COMMENTS

received after January 19, 2021 and
provided to the EPC with the February 18, 2021 Staff Report

Residential Glazing at 20% Requirement

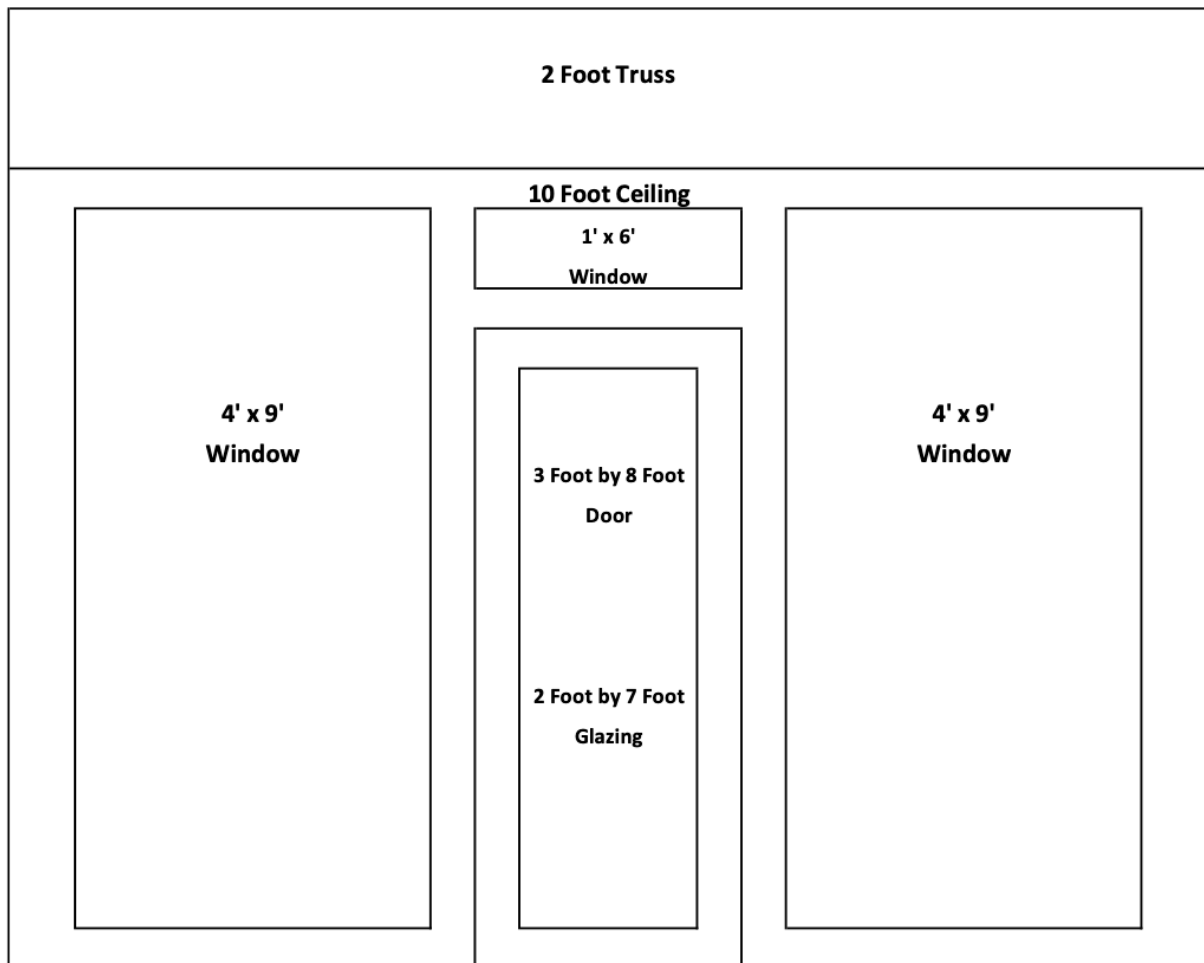
This first diagram shows what a 20% ground floor residential glazing requirement would look like. This residential unit is 13.5 feet wide. It has a 10-foot ceiling and a 2-foot truss for a total of 12 feet on the ground floor. The windowsill begins 30 inches above the finished floor. The windows are of an urban residential character in that they are twice as tall as they are wide.

Even for this relatively narrow unit, the two large windows shown on the ground floor provide ample light, eyes on the street, an attractive design, and some privacy and safety.

For the reasons above, I am asking the Planning Department and the City of Albuquerque to consider requiring residential buildings in the UC-MS-PT areas where minimum glazing requirements apply to institute a minimum 20% glazing requirement on the ground floor. This would certainly be a way to balance the safety and security of residences with the need for appealing urban spaces.
